**STATE OF CONNECTICUT
CONNECTICUT SITING COUNCIL**

**Petition of BNE Energy Inc. for a
Declaratory Ruling for the Location,
Construction and Operation of a 3.2 MW
Wind Renewable Generating Project on
Winsted-Norfolk Road in Colebrook,
Connecticut (“Wind Colebrook North”)**

Petition No. 984

REBUTTAL TESTIMONY OF MICHAEL LIBERTINE, LEP

**Exhibit 3 - Libertine Rebuttal Testimony 4-25-2011
 Rock Hall Property**

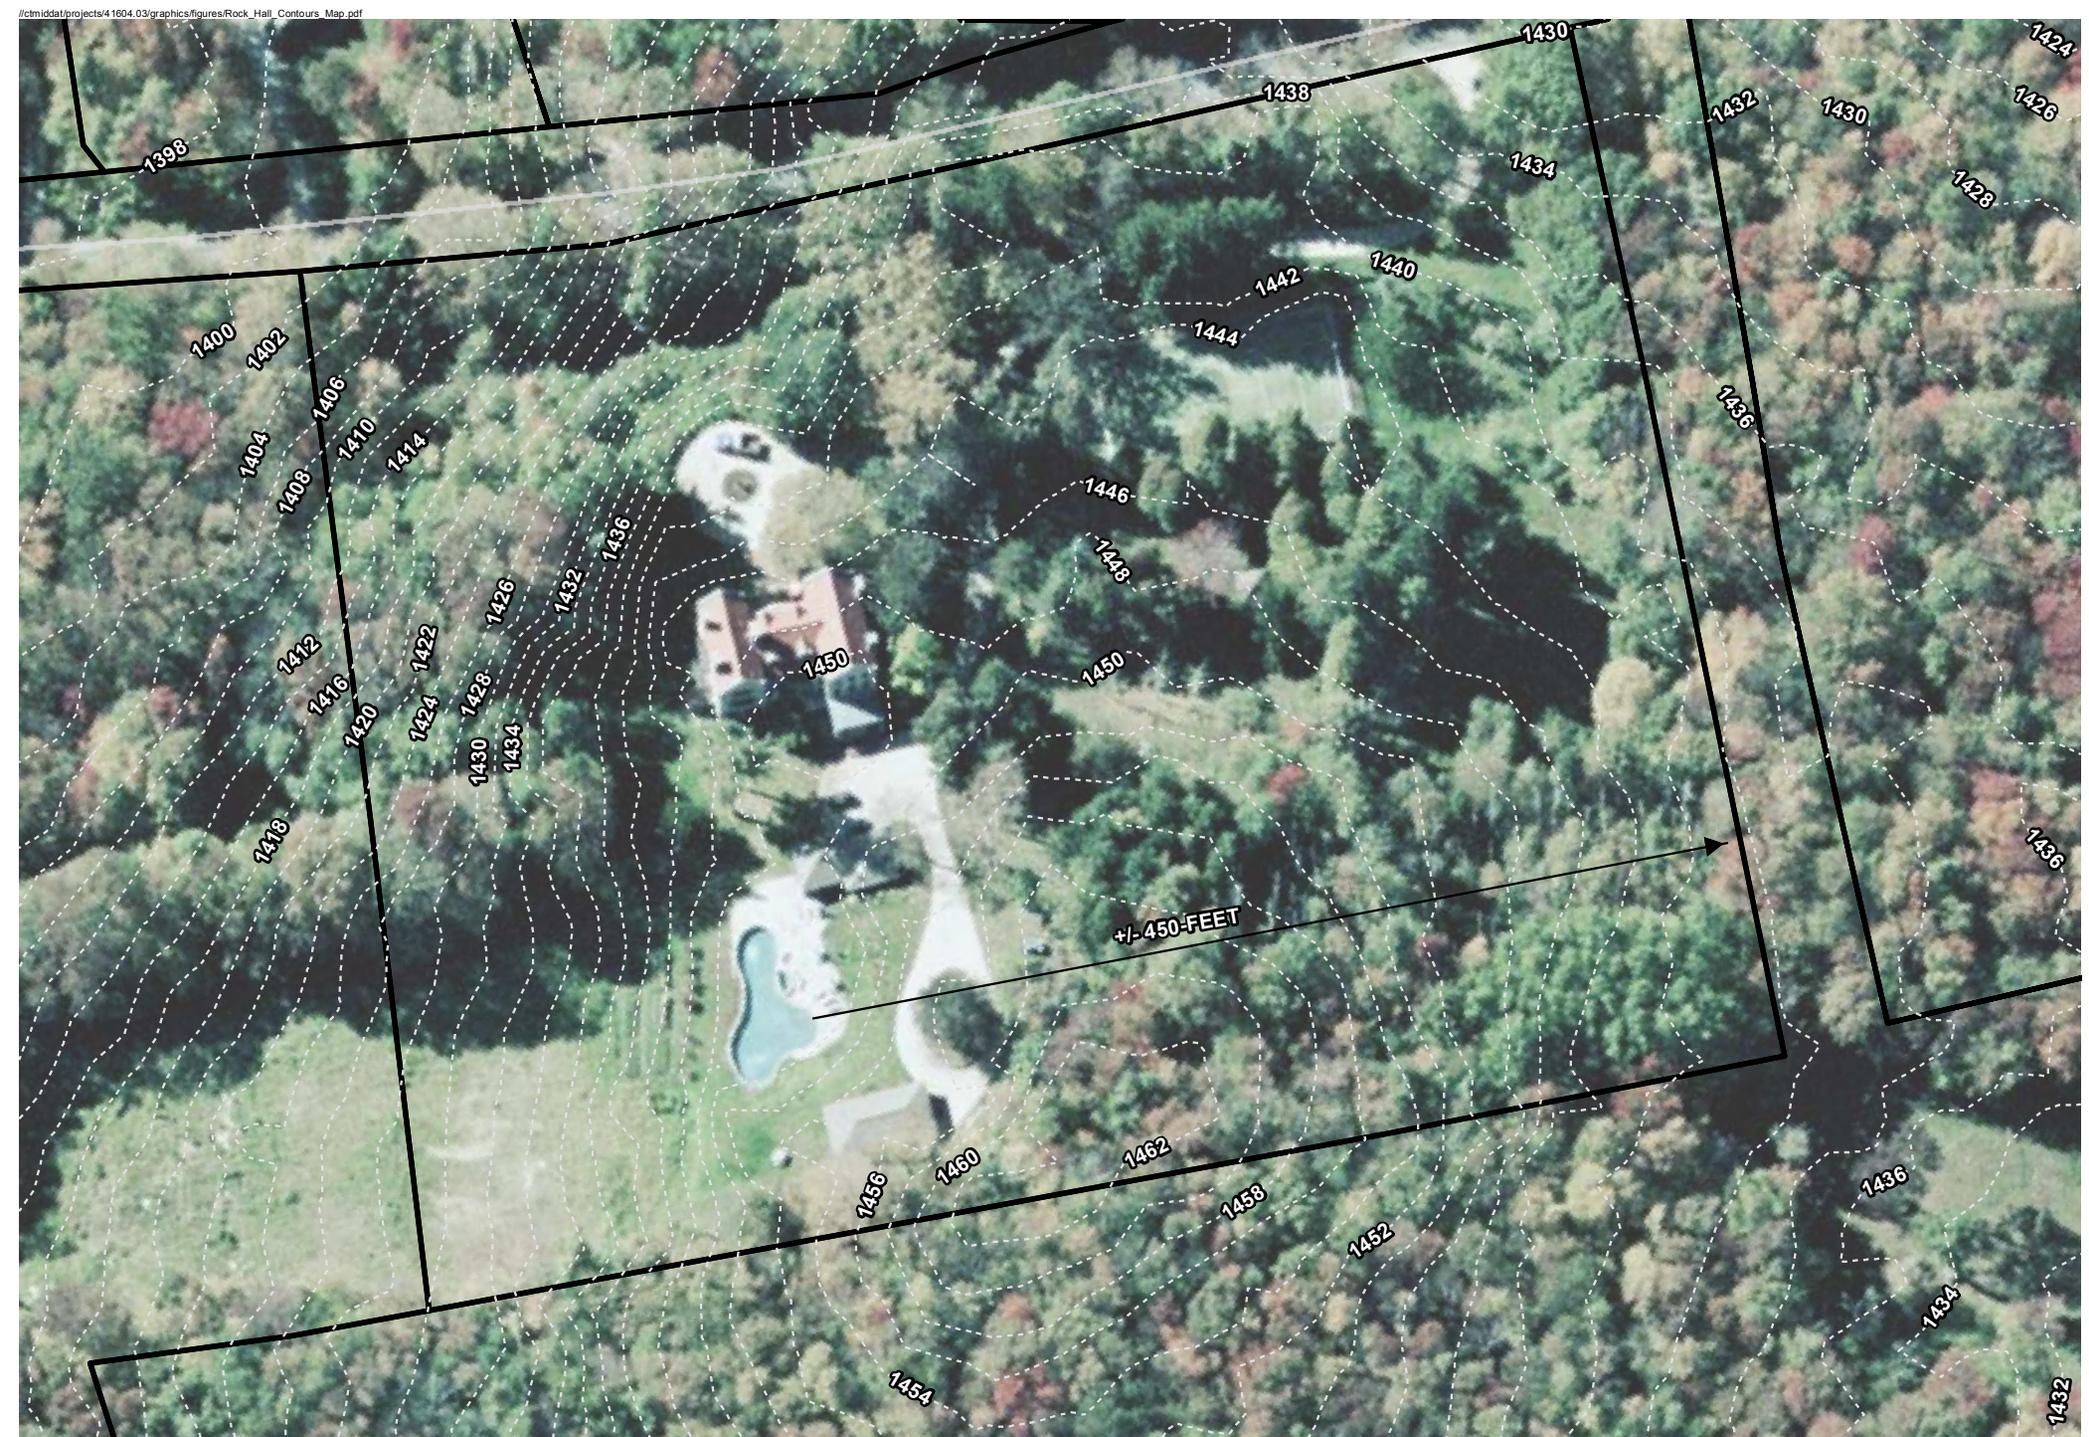
- Rock Hall Laux Lodging Simulations - Figures 2, 3 and 4 of the Planimetrics submission represent views "behind" the residence, defined by Mr. Chalder as to the east of the building near the pool area. I do not believe these three simulations provide useful information because they reportedly depict conditions from 10, 20 and 30 feet above ground level. When asked under cross examination about these simulations and the incremental view heights in the petition 983 proceeding, Mr. Chalder suggested that the property rises upward from the pool and that the three scenes provide views from varying heights as one steps away from the pool onto presumably higher ground. However, it is clear from the materials submitted and substantiated by Mr. Chalder when asked, that these shots are all from the same location; the "eye level" of the computer model's lens was simply raised in 10-foot increments. A review of LiDAR topographic data for the property (obtained from the same source used by both Planimetrics and VHB to create the respective terrain models) indicates that the approximate ground elevation at the pool area is 1450± feet and gradually increases to a high point of 1462± feet then drops back down in elevation to 1440±, all over a distance of approximately 450 linear feet to the northern property line. Beyond a distance of approximately 120 feet north of

the pool, the property is wooded. See the aerial photograph provided in Exhibit 3 of this document for reference. Although the use of a 10-foot height above ground level is arguable, I find no basis for assuming 20 or 30 feet elevation gains on the property.
